## **TECHNICAL BULLETIN**

**412RSAF-24-29**

**MODEL AFFECTED:** 412RSAF

**SUBJECT:** BLEED AIR DUCT CLAMP, REPLACEMENT OR REWORK OF

**Figure 1  
 Bleed Air Duct Installation**

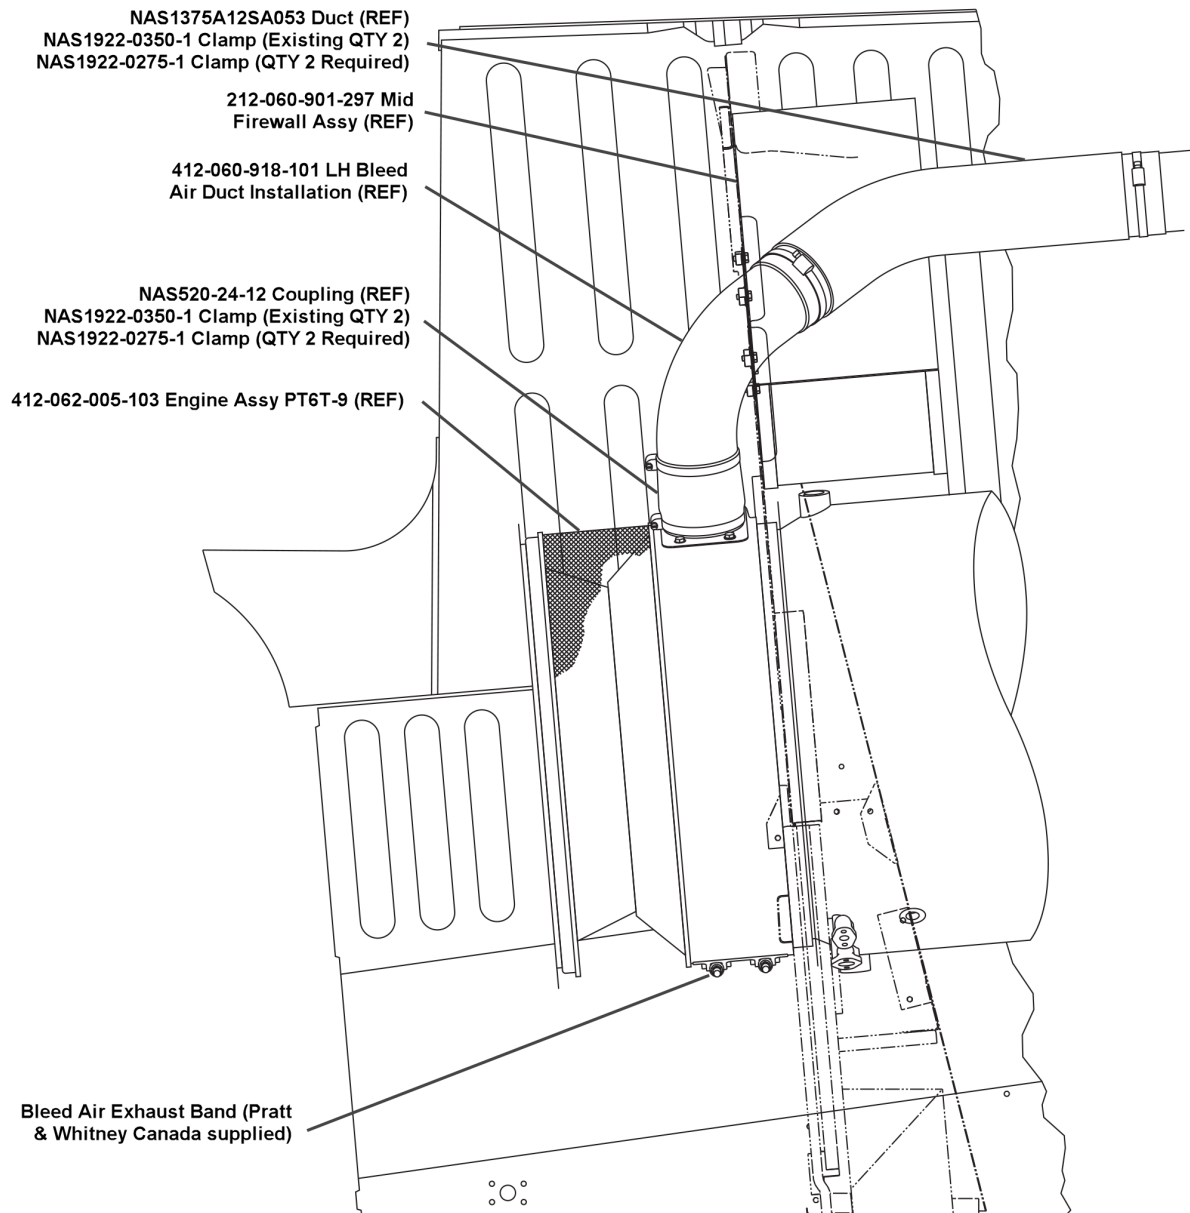
Bell has discovered that clamps NAS1922-0350-1, used in the bleed air duct installations 412-060-918-101/-102, are too large and in some cases the "tail" of the clamp failed in service due to vibration causing a possible foreign object debris (FOD) condition. This technical bulletin provides instructions to either trim the excess material or replace the existing clamps with smaller clamp NAS1922-0275-1.

2. Gain access to the LH duct installation 412-060-918-101 (Refer to Figure 1).
3. Inspect the four existing clamps NAS1922-0350-1 for excess material, more than 0.25 inch (6.35 mm), beyond the clamp screw mechanism.
  - a. If the clamp has excess material:
    - (1) Either cut off the excess material and trim the sharp edges or replace with smaller clamp NAS1922-0275-1.
  - b. If any of the existing clamps NAS1922-0350-1 excess material has broken off:
    - (1) Inspect the engine compartment for the broken off material.

- (2) If the excess material cannot be located inspect the engine compressor in accordance with the Pratt & Whitney Canada PT6T-9 Engine Maintenance Manual.
    - (3) Either trim the sharp edges or replace with smaller clamp NAS1922-0275-1.
4. Gain access to the RH duct installation 412-060-918-102 (Refer to Figure 1).
5. Repeat step 3.
6. Make an entry in the helicopter logbook and historical service records indicating compliance with this Technical Bulletin.
